STATE OF VERMONT
AGENCY OF TRANSPORTATION

PROPOSED IMPROVEMENT
BRIDGE PROJECT

TOWN OF BRISTOL, ADDISON COUNTY
ROUTE NO : TH 5 CLASS II, LOCAL ROAD (SOUTH STREET) BRIDGE NO : 31

RECORD PLANS

INT. DIAPHRAGMS - TYPE D1
(DEVELOPED)
FRAMES NS OR FS OF STIFFENERS - SEE WS1

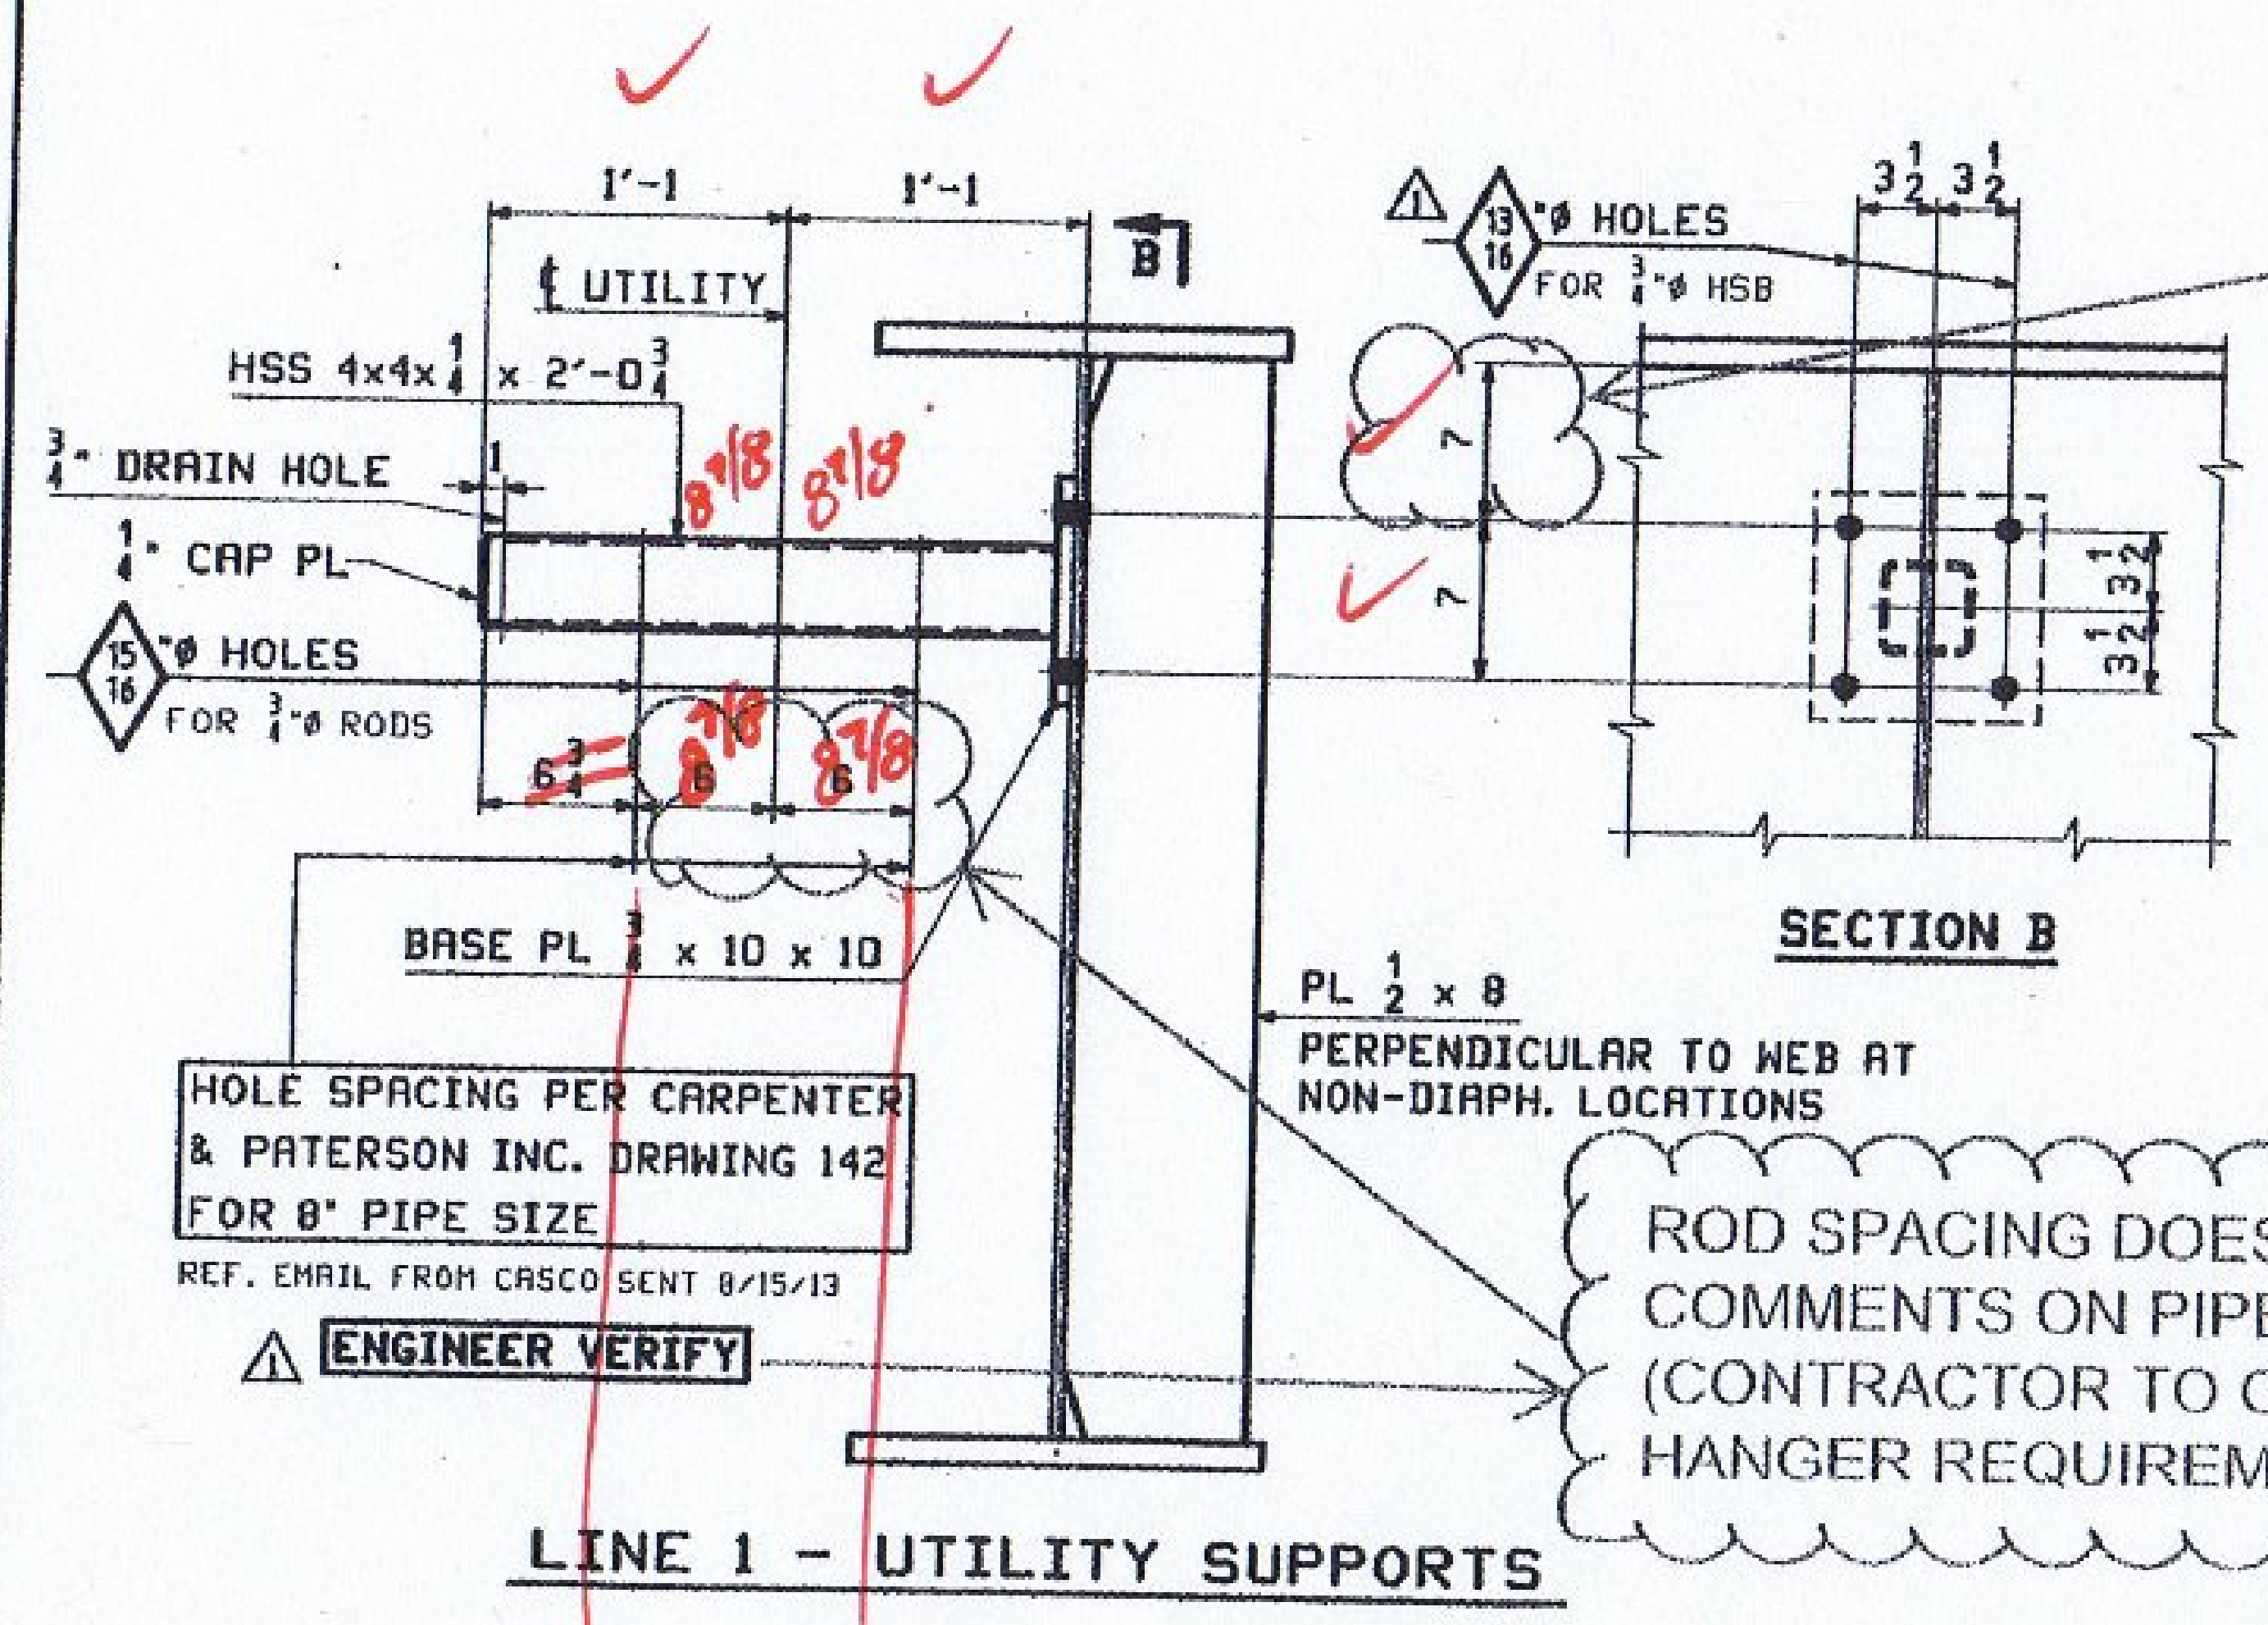
*CONTRACTOR VERIFY THIS DIMENSION (COORDINATE WITH FIELD DIMENSIONS AND PIPE HANGER SUBMITTAL).

ROD SPACING DOES NOT MATCH PLANS SEE COMMENTS ON PIPE HANGER SUBMITTAL (CONTRACTOR TO COORDINATE PIPE HANGER REQUIREMENTS TO FABRICATOR)
